City of Plymouth Planning Commission

Regular Meeting Agenda

Wednesday, March 9, 2022 – 7:00 p.m.
City Hall & Online Zoom Webinar

**Special Land Use and
Site Plan Review
For
Plymouth, Michigan**

Sheet No. A-03

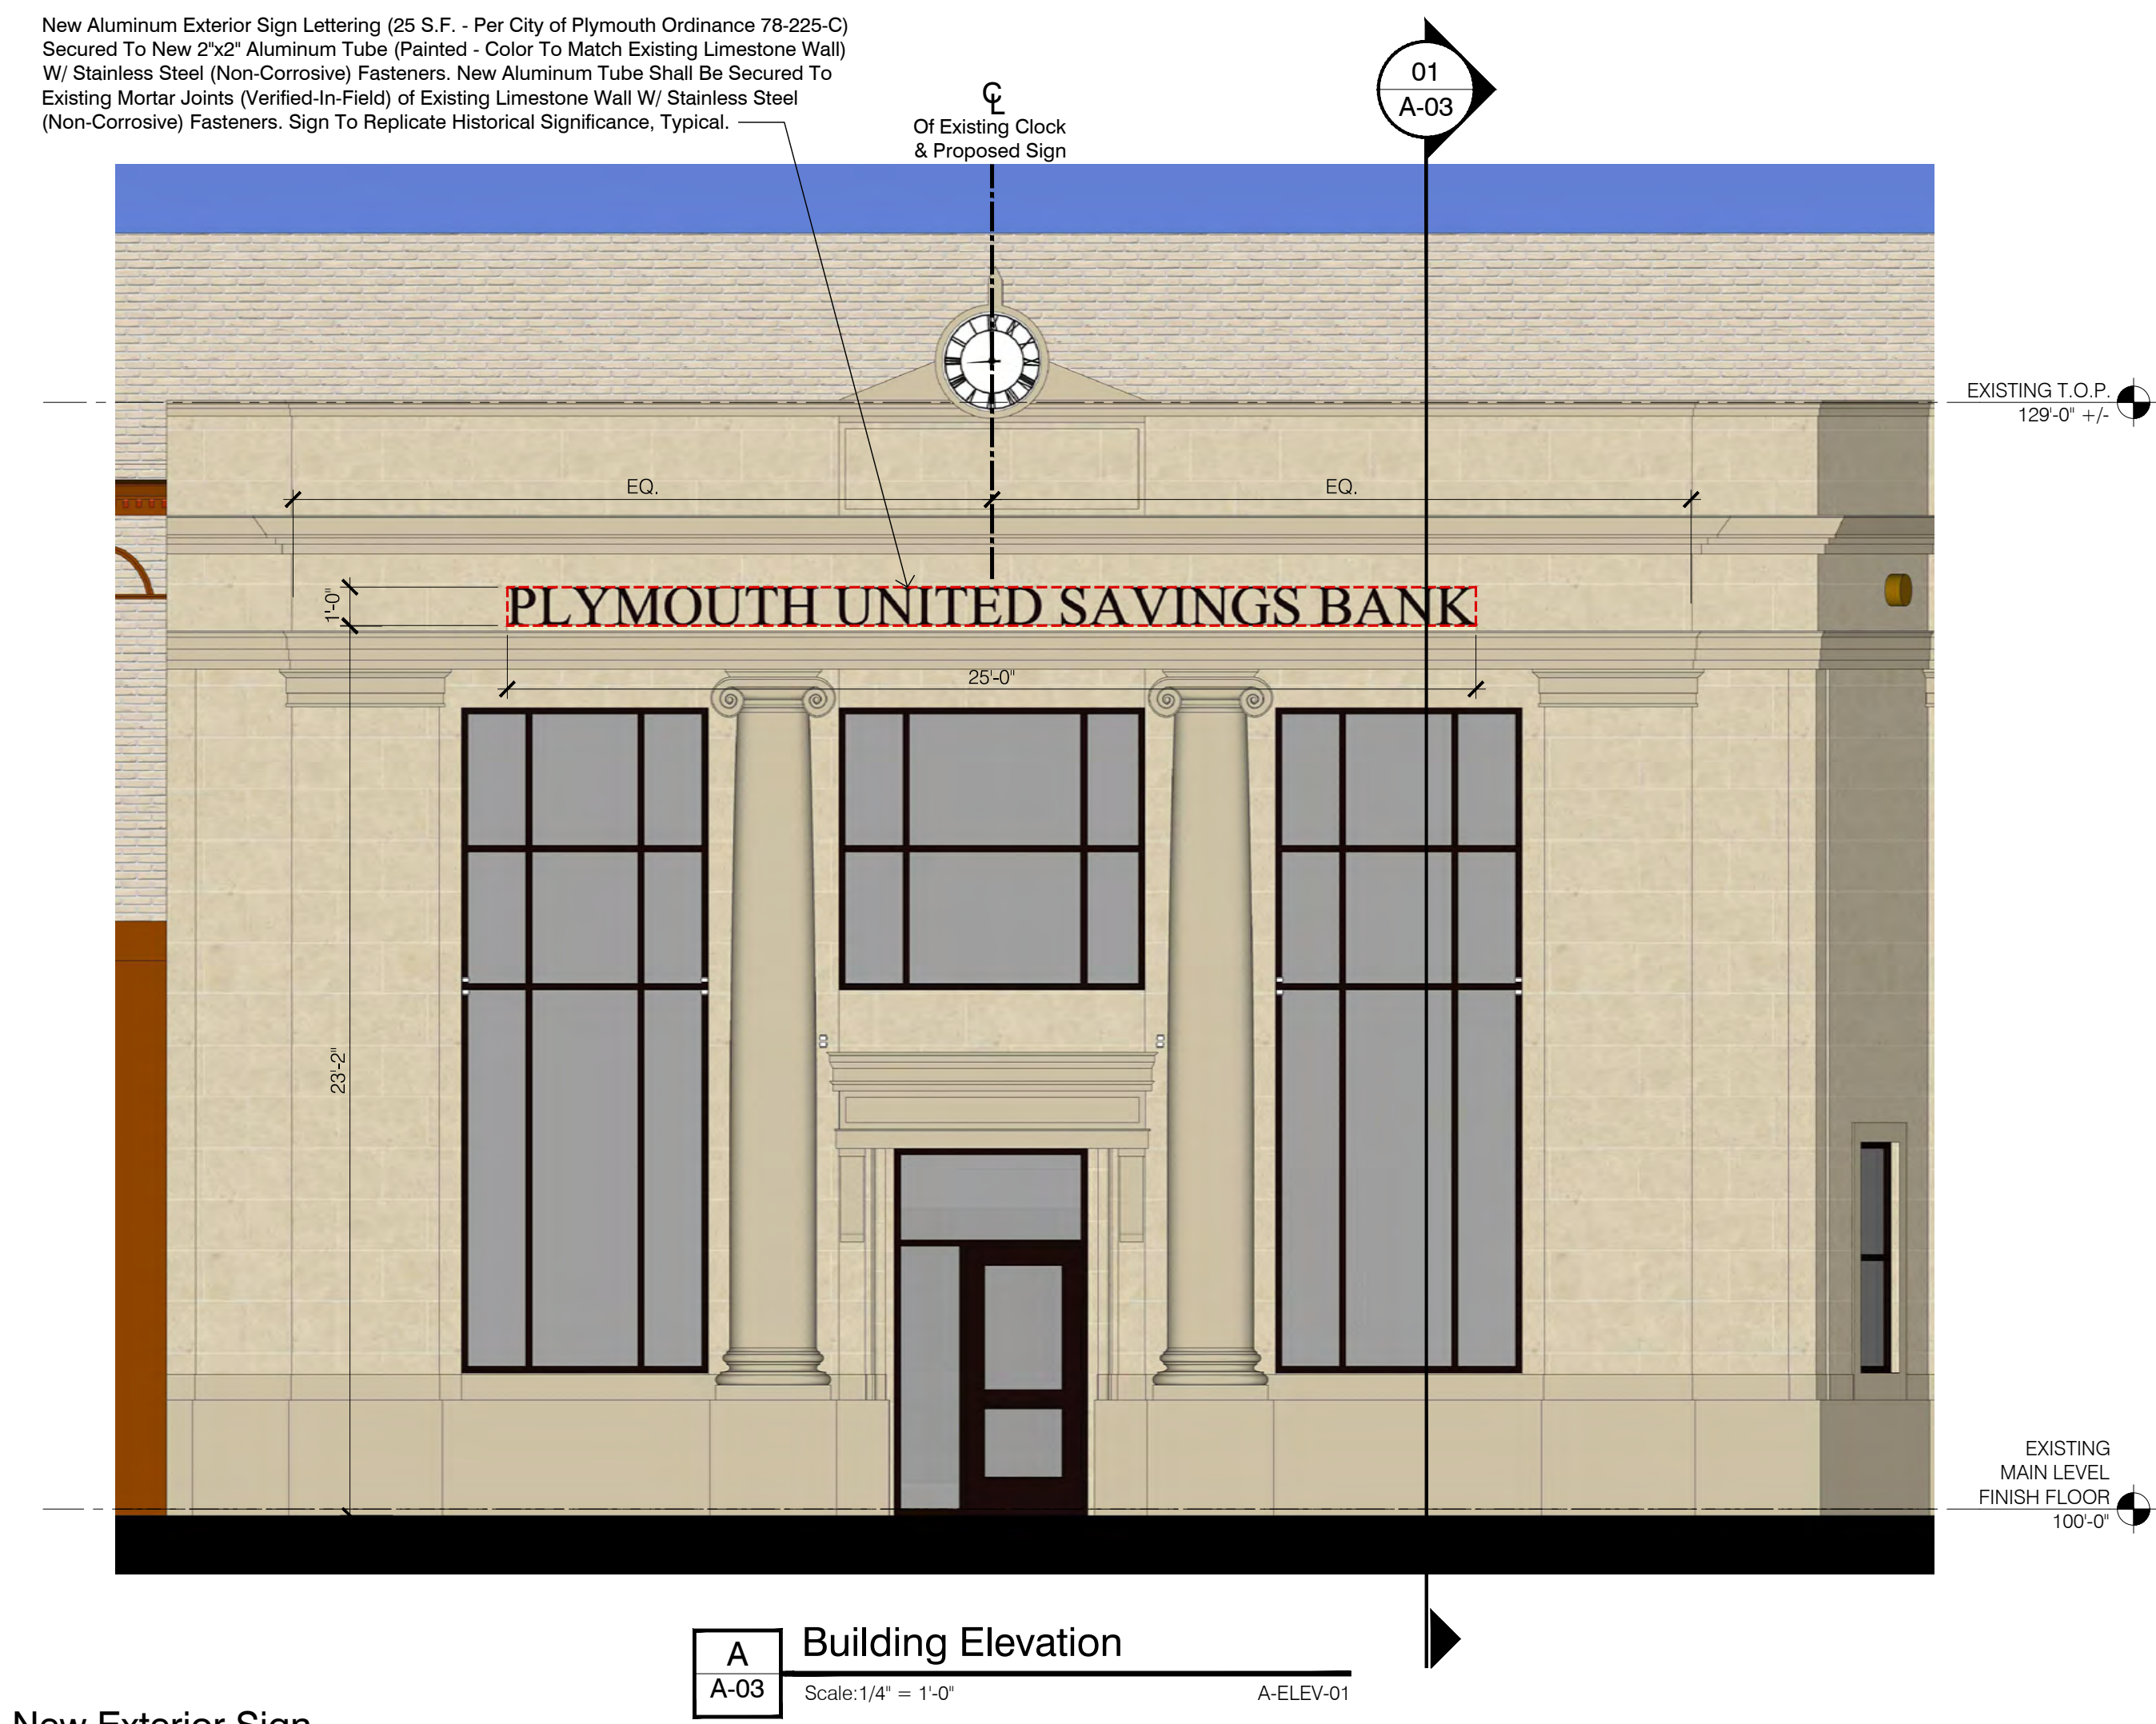
The plans indicate that the applicant is proposing to place light fixtures in the window/door recesses on the building facade. The ordinance states that building mounted lighting intended to attract attention to the building and/or use and not strictly designed for security purposes shall not be permitted. The lighting highlights the building’s architecture, and is not necessary for security purposes. Also, there is a street light directly in front of this building on Main St., and another along Penniman. These lights are not permitted by the ordinance, and should be removed.

A wall sign is shown on the site plans. The ordinance permits one wall sign per business site that is no greater than 25-square feet in area.

The plans show signage along the top of the building stating: "Plymouth United Savings Bank." Is this the actual text of the proposed signage? If not, the proposed signage should be shown on the site plan to confirm that it meets size requirements.

The Owner will be re-utilizing the name of the original Bank Building from the 1920's. The new name of the Restaurant has not been determined but will probably be branded from the new signage " Plymouth United Savings Bank ". The proposed signage meets Ordinance size and will be shown on the Site Plan.
